Comments of Chief Engineer/Mainland North, Drainage Services Department

Temporary Shop and Services for a Period of 5 Years,
Lot 283 S.A RP (Part) in D.D. 109, Kam Tin, Yuen Long,
New Territories

Drainage Proposal

May 2026

FIGURE NUMBER
FIGURE 3

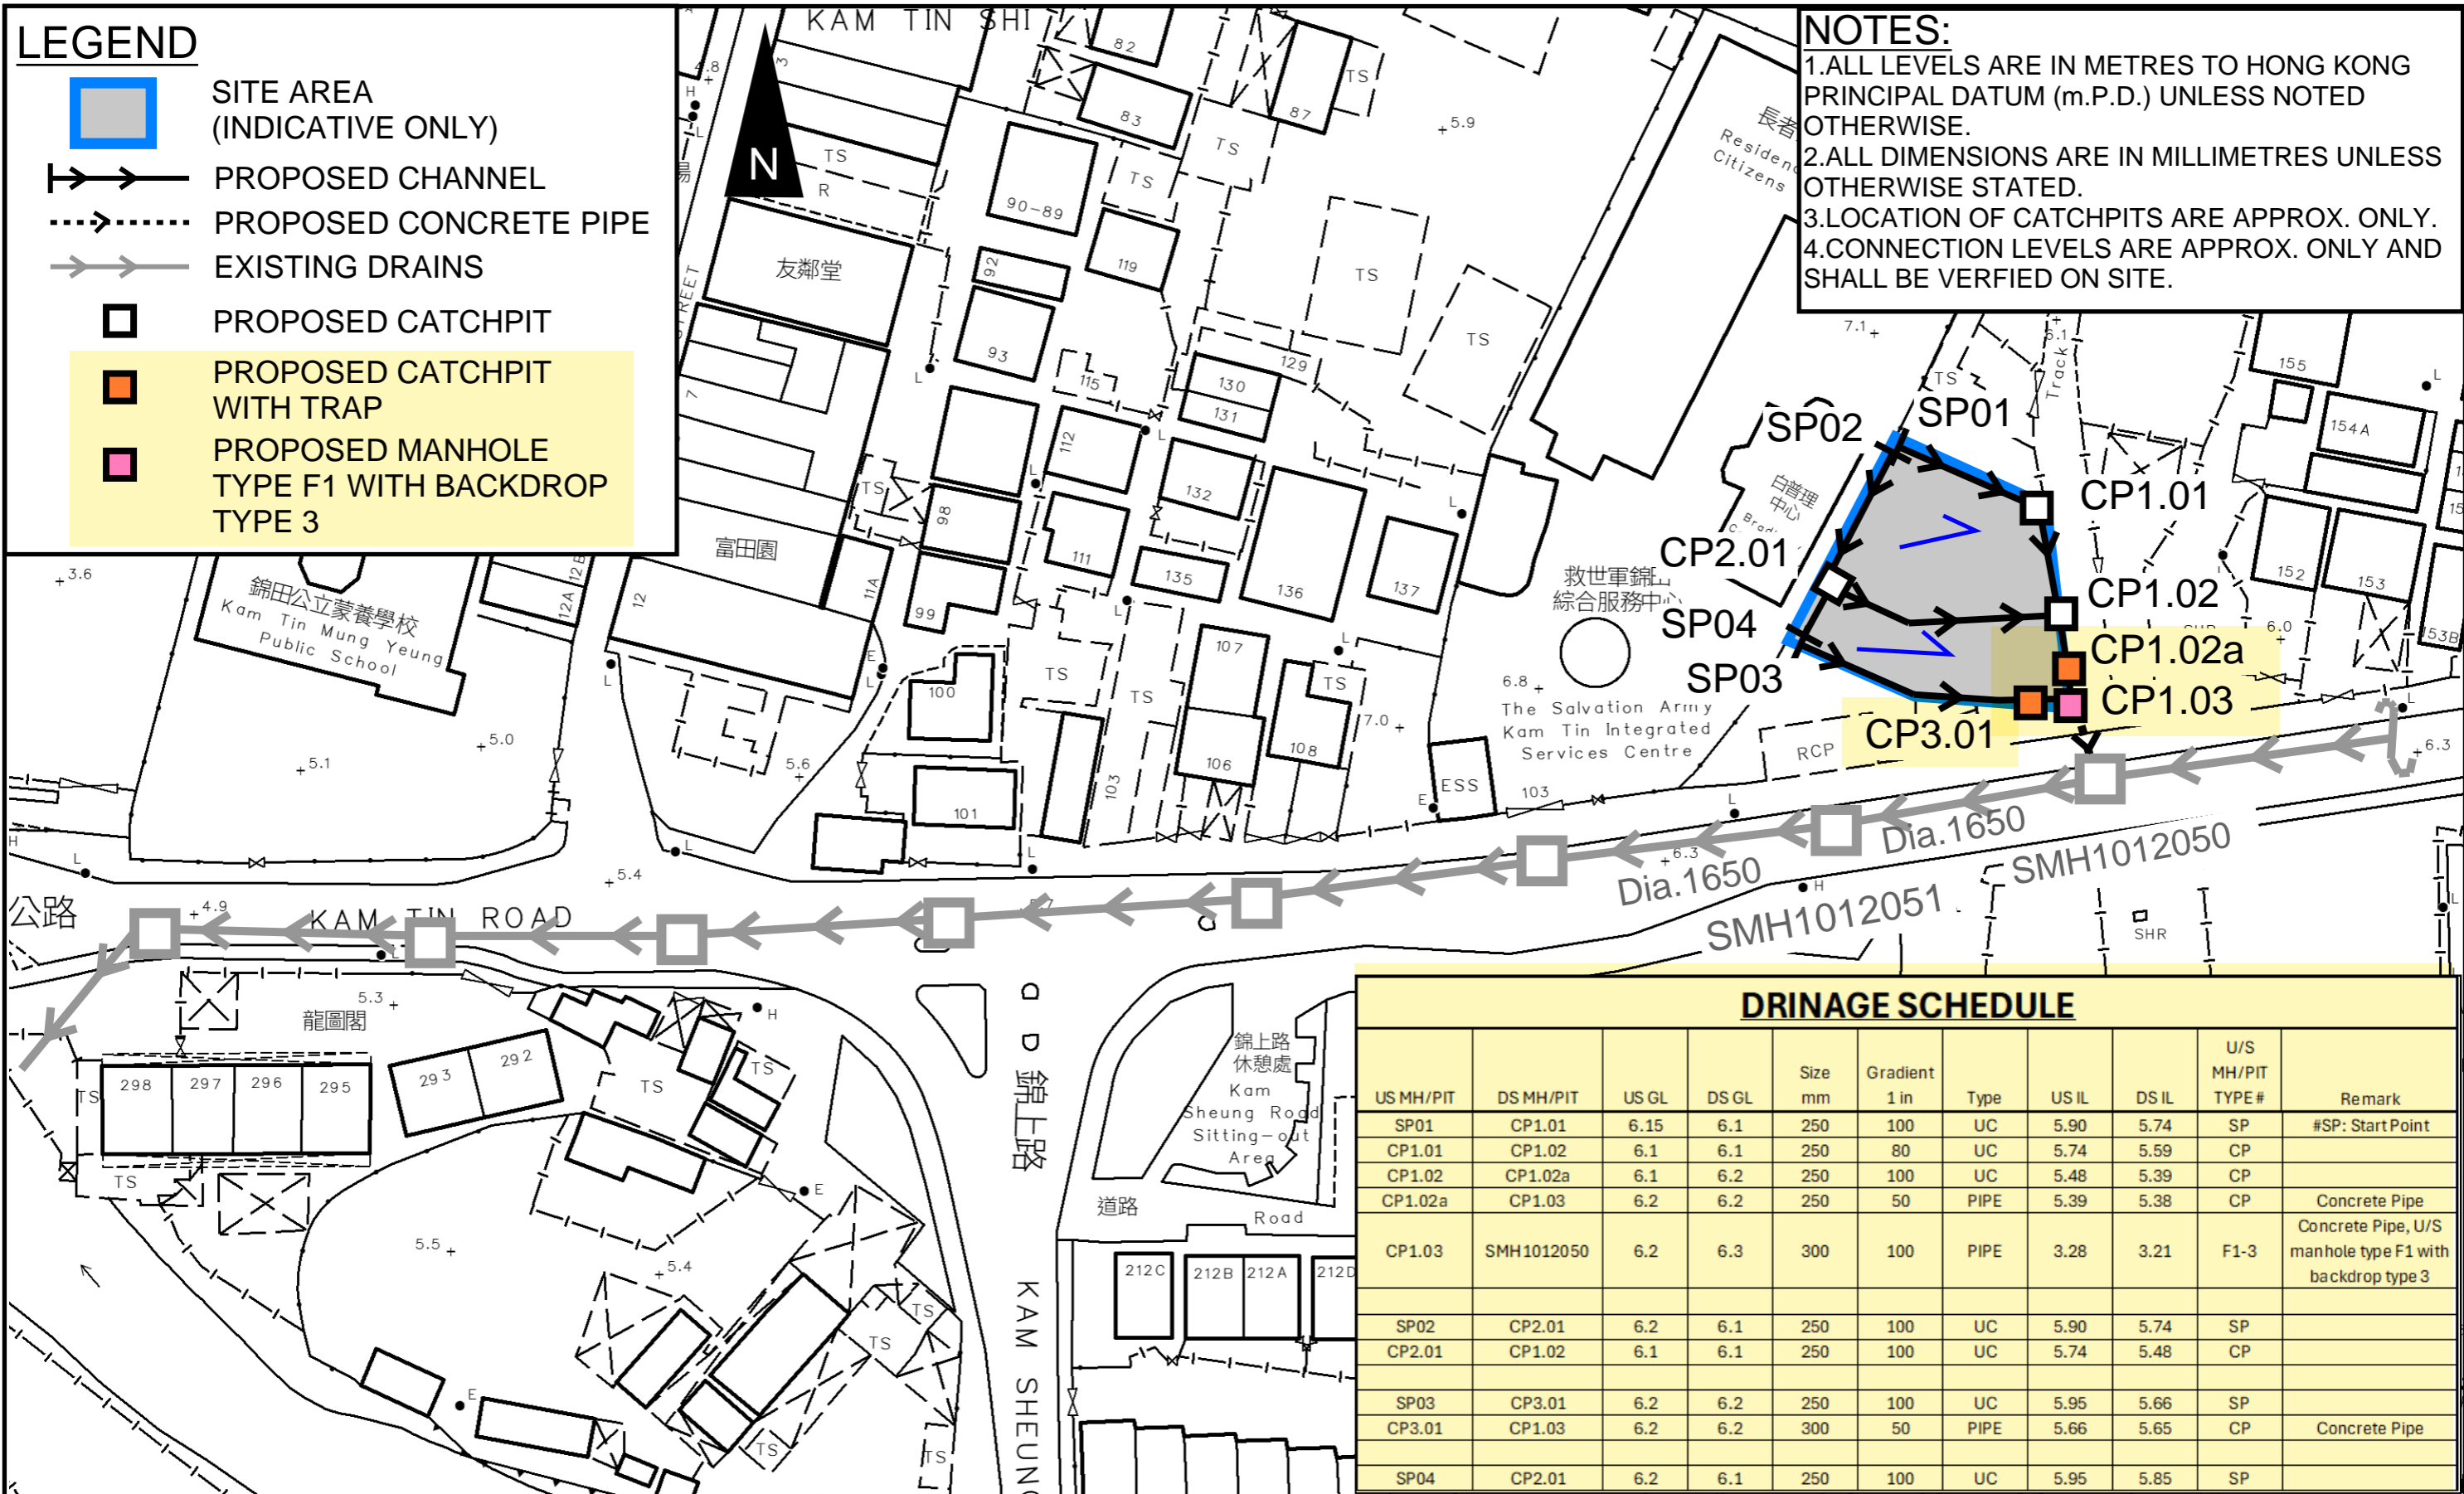
| Item | Comments | Responses |
|----------|---|--|
| 1 | Figure 3: The applicant should clarify discrepancies of invert levels of the proposed terminal manhole CP1.03 shown on the submitted drawing. | Noted. Further to the discussion with DSD, the manhole CP1.03 is revised to manhole type F1. The IL is updated in Figure 3. |

| Item | Comments | Responses |
|----------|---|--|
| 3 | Sand trap or provision alike should be clearly indicated on the proposed drainage plan and provided before the collected runoff is discharged to the public drainage facilities. A sand trap/desilting type catchpit should be provided prior to connection to the proposed stormwater terminal manhole or to the downstream public stormwater drainage system. The sand trap/desilting type catchpit should be regularly desilted by the applicant to prevent sand, silt, cementitious materials or other objects from being washed down into the public stormwater drainage system. | Further to the discussion with DSD, catchpits with trap are proposed before connection to manhole CP1.03. Figure 3 is updated for your perusal. |

STANDARD MANHOLE
TYPE F1

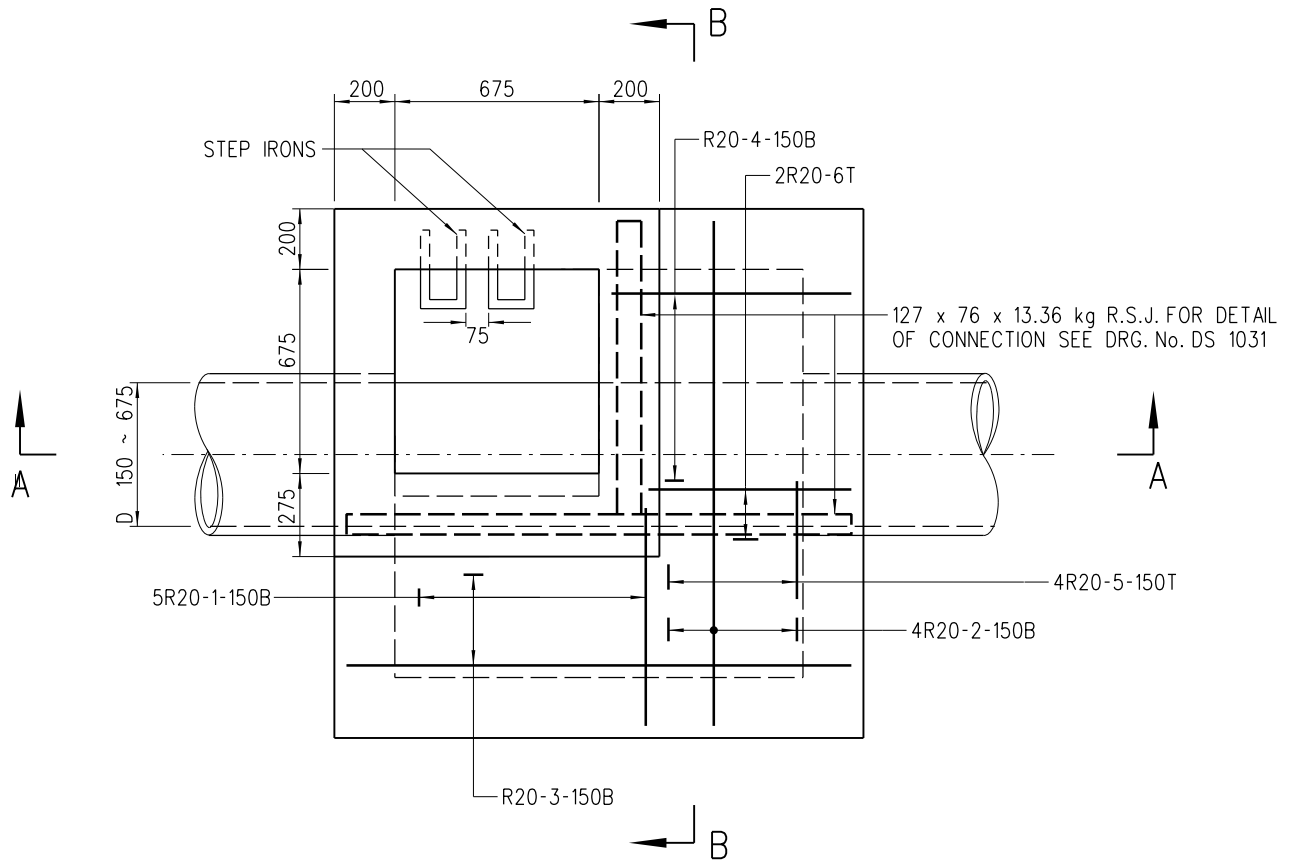
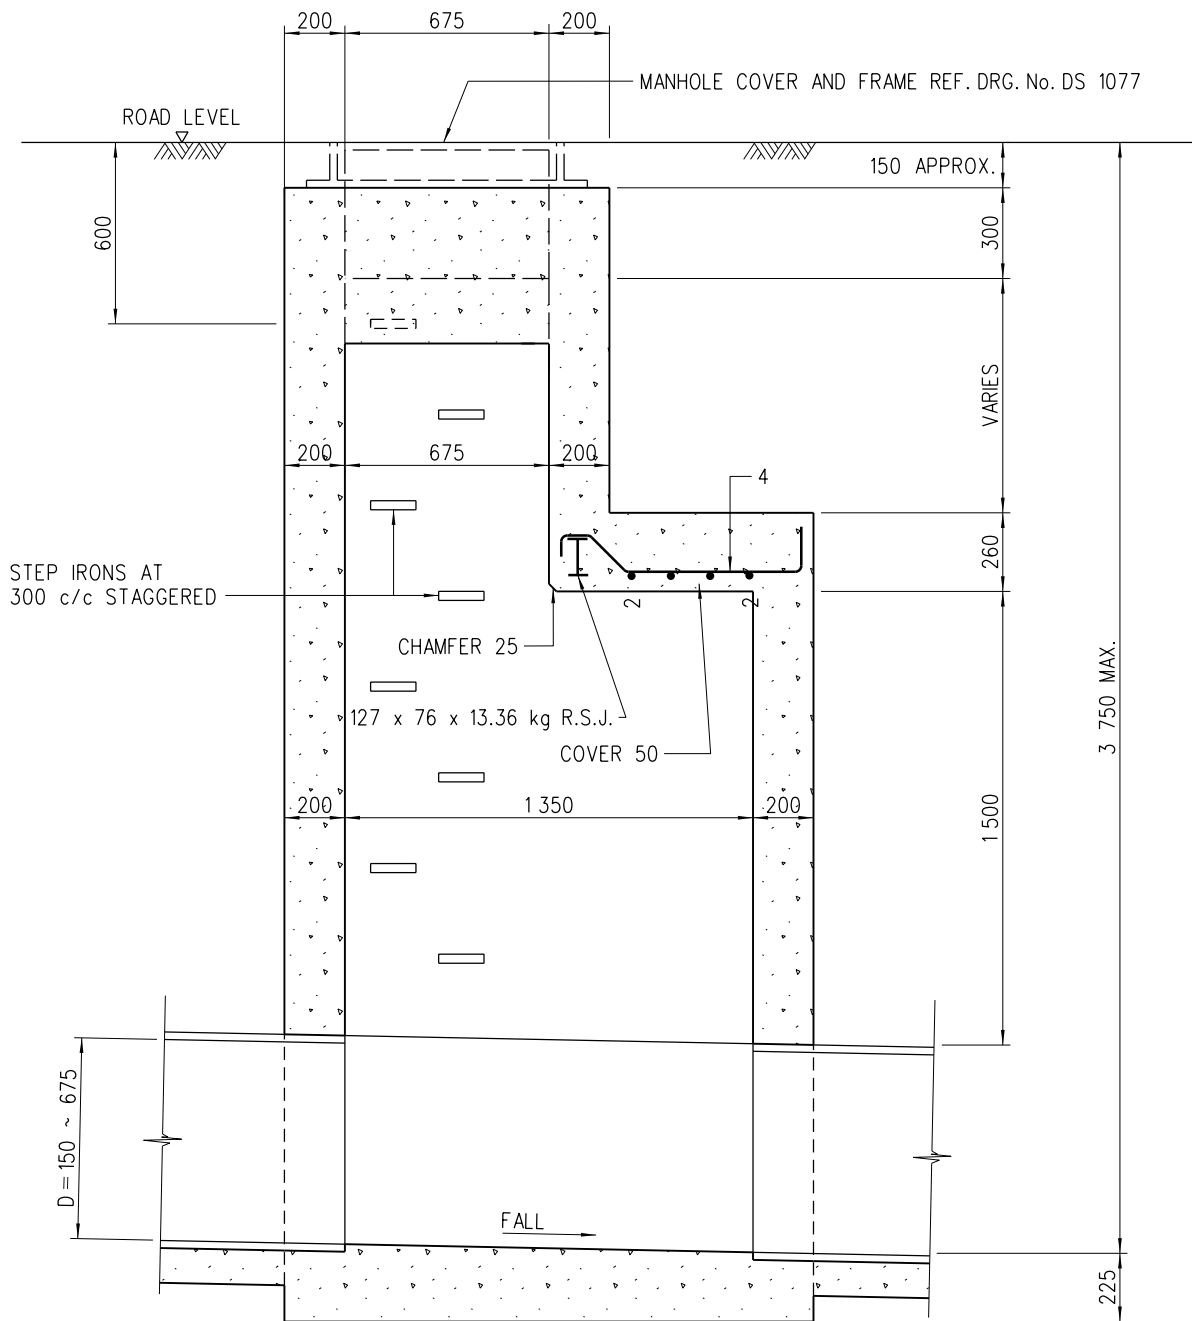
| Item | Comments | Responses |
|----------|---|--|
| 2 | The applicant should review construction details of the proposed terminal manhole CP1.03 since the proposed construction details were not applicable for backdrop manhole. Also, the applicant should review design of the proposed stormwater drainage system in order to minimize the need of adopting backdrop manhole. | Further to the discussion with DSD, sand traps are provided before connection to manhole CP1.03. As the existing manhole (SMH1012050) for connection is 3.6m depth, backdrop manhole is proposed to provide the enough drop in such short distance. The manhole CP1.03 to be maintained by the development. Standard drawings are shown in Appendix D. |
